IOWA DOT		REVISION	
2		04-18-17	
STANDARD ROAD PLAN		DR-101	
SHEET 1 of 1

PIPE CULVERT
(BEDDING AND BACKFILL)

TRENCH INSTALLATION

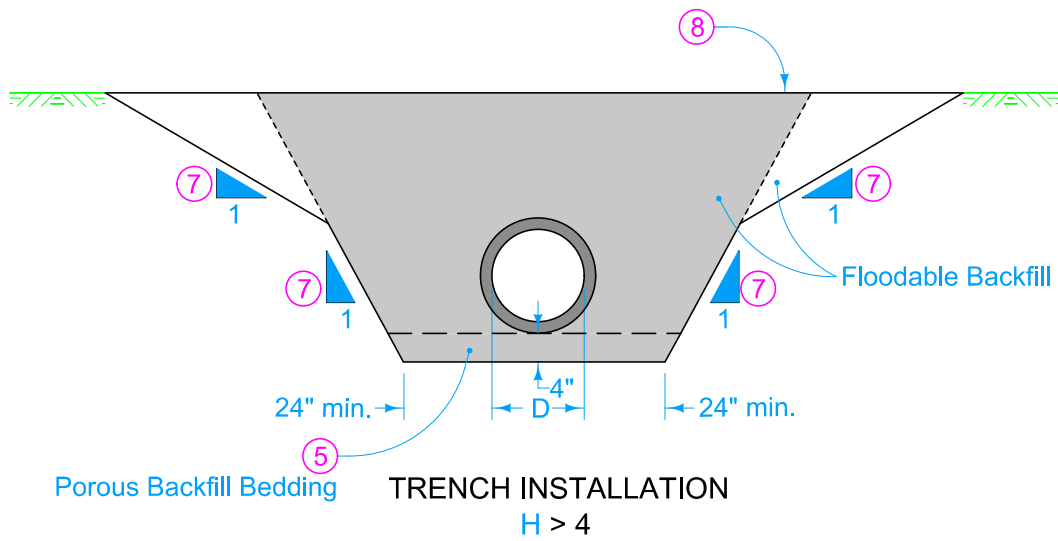
REVISIONS: Changed "Porous Backfill" to "Porous Backfill Bedding" for clarity. Modified trench installation detail for H>4' to clarify pay limits.
